**INITIAL EXPRESS TERMS  
FOR  
PROPOSED BUILDING STANDARDS  
OF THE  
DIVISION OF THE STATE ARCHITECT (DSA-AC)

REGARDING PROPOSED CHANGES TO  
THE CALIFORNIA BUILDING CODE  
CALIFORNIA CODE OF REGULATIONS, TITLE 24, PART 2

2016 CALIFORNIA BUILDING CODE  
INTERVENING CODE CYCLE**

**Figure 11B-404.2.4.3**  
**Maneuvering Clearances at Recessed Doors and Gates**

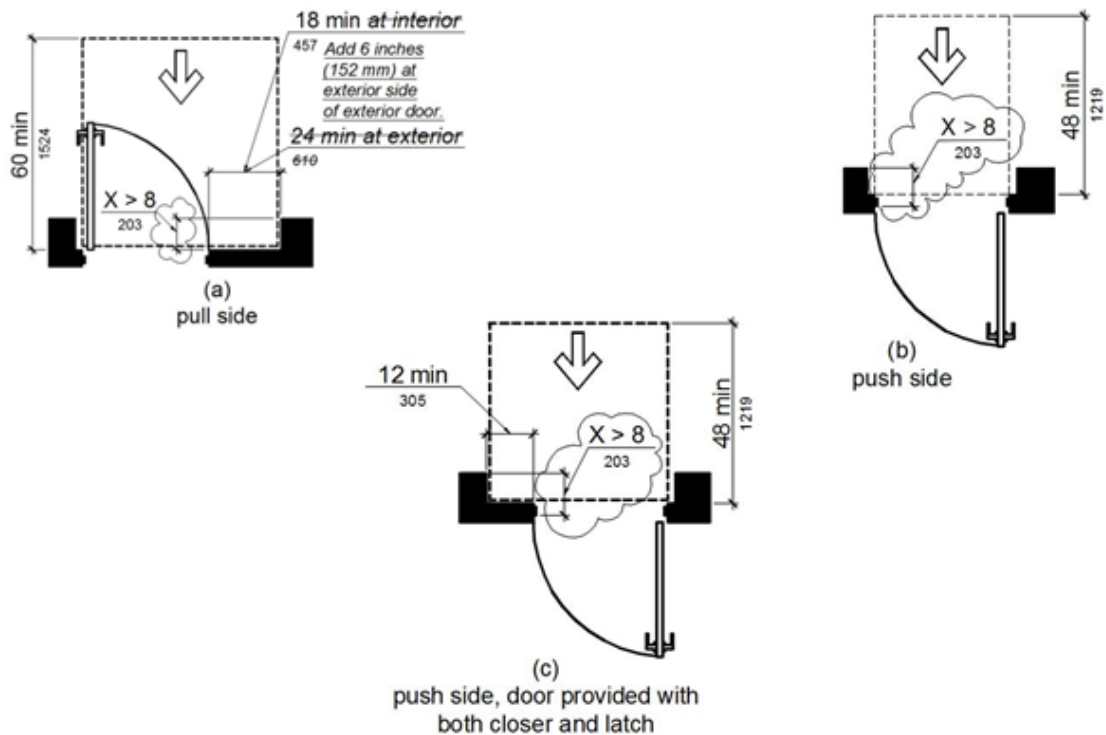
**ITEM 11B.08**

**DIVISION 4: ACCESSIBLE ROUTES**

**FIGURE 11B-604.7.1**  
**DISPENSER OUTLET LOCATION**

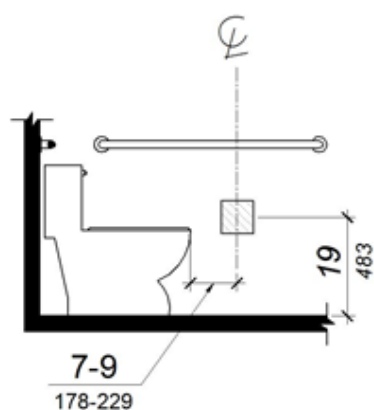
(begin underline) **11B-604.7.1 Dispensers.** (end underline) Toilet paper dispensers shall comply with Section 11B-309.4 and shall be 7 inches (178 mm) minimum and 9 inches (229 mm) maximum in front of the water closet measured to the centerline of the dispenser. The outlet of the dispenser shall be *below the grab bar, 19 inches (483 mm) minimum* above the finish floor and shall not be located behind grab bars. Dispensers shall not be of a type that controls delivery or that does not allow continuous paper flow.

**FIGURE 11B-604.7.2**  
**DISPOSAL UNIT LOCATION**

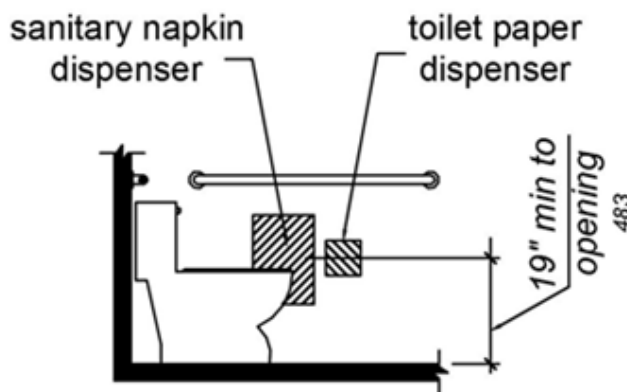
(begin underline) **11B-604.7.2 Disposal units.** *Sanitary napkin disposal units, if provided, shall comply with Section 11B-309.4 and shall be wall mounted and located on the sidewall between the rear wall of the toilet and the toilet paper dispenser, adjacent to the toilet paper dispenser. The disposal unit shall be located below the grab bar, with the opening of the disposal unit 19" minimum (483 mm) above the finish floor. Combination accessory units are not permitted to encroach into the space required by Section 11B-609.3.* (end underline)

**Figure 11B-703.7.2.1  
International Symbol of Accessibility**

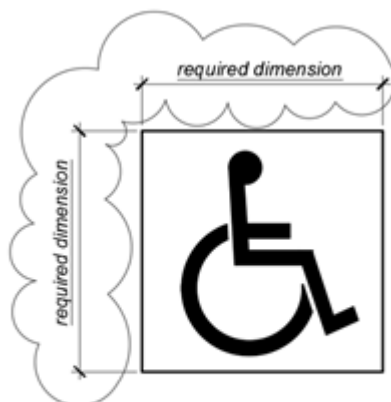
**11B-703.7.2.1 International Symbol of Accessibility.** The International Symbol of Accessibility shall comply with Figure 11B-703.7.2.1. *The symbol shall consist of a white figure on a blue background. The color blue shall approximate FS 15090 in Federal Standard 595C. (begin underline) A border may be provided inside or outside of the minimum required ISA dimension. (end underline)*

**Figure 11B-705.1**  
**Size and Spacing of Truncated Domes**

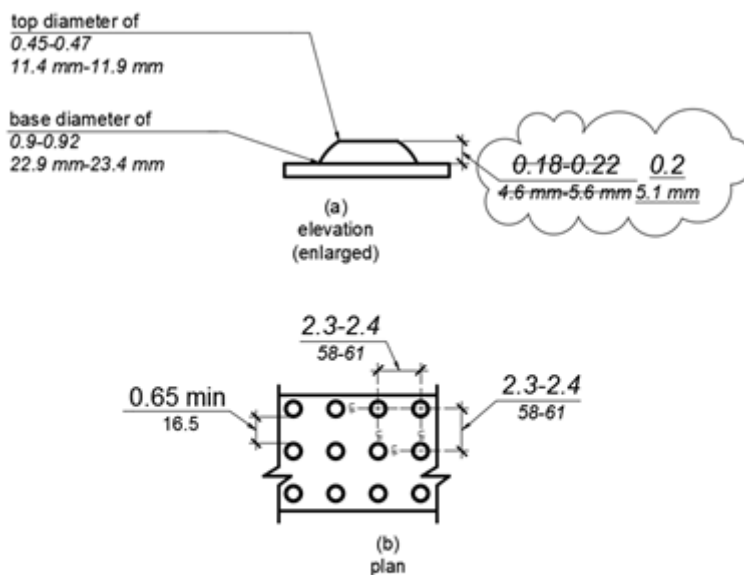
ITEM 11B.12

DIVISION 7: COMMUNICATION ELEMENTS AND FEATURES
